JV33シリーズ用白インク(SS21W)をお使いのお客様へ

新白インク (SS21W-2)をお使いになる前に

To our Customers using White Ink (SS21-W2) for JV33 Series

Before using new White Ink (SS21-W2)

機能追加位置

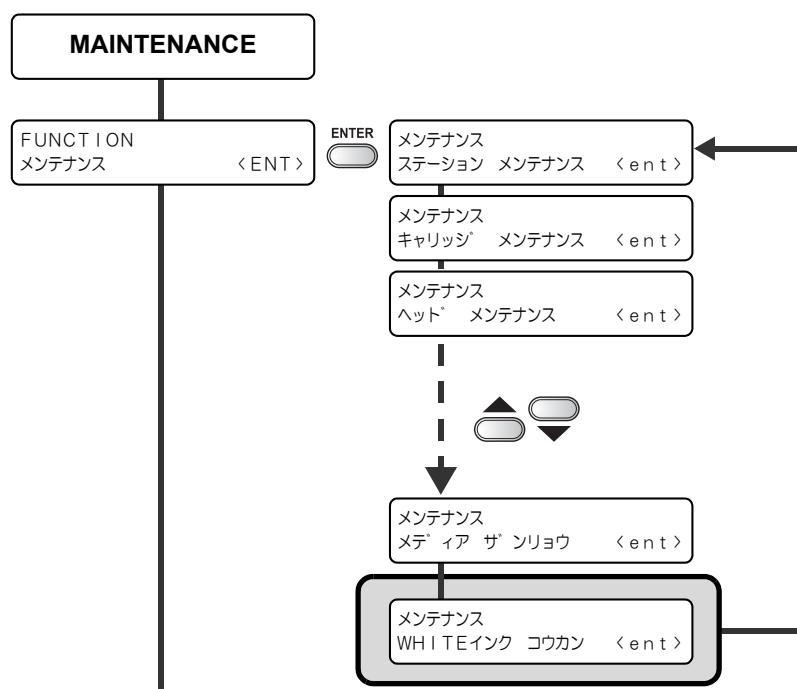
新白インク (SS21W-2) をセットしたときに **END** キーを押した場合でも、FUNCTION メニューから WHITE インクコウカンをすることができます。

本機能は、メンテナンスマニュー内の下記の位置に追加になりました。
詳しくは、取扱説明書 6 章「機能フローチャート」を参照してください。

- 本機能は、SS21 インク 6 + W 色充填時のみ選択可能です。

Position to add new function

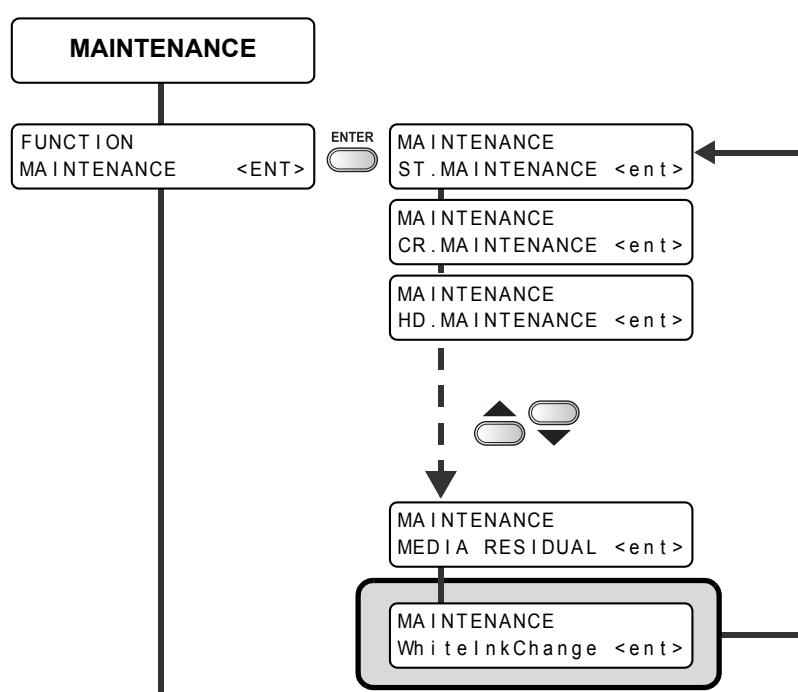
Even when the new white ink (SS21W-2) is set and the **END** key is pressed, you can perform WHITE INK CHANGE from the FUNCTION Menu.

This function has been added in the following place in the Maintenance Menu.
For details, please refer to the Operation Manual Chapter 6 “Function Flowchart”.

- This function can be selected only in the case of filling SS21 ink 6 + W colors.
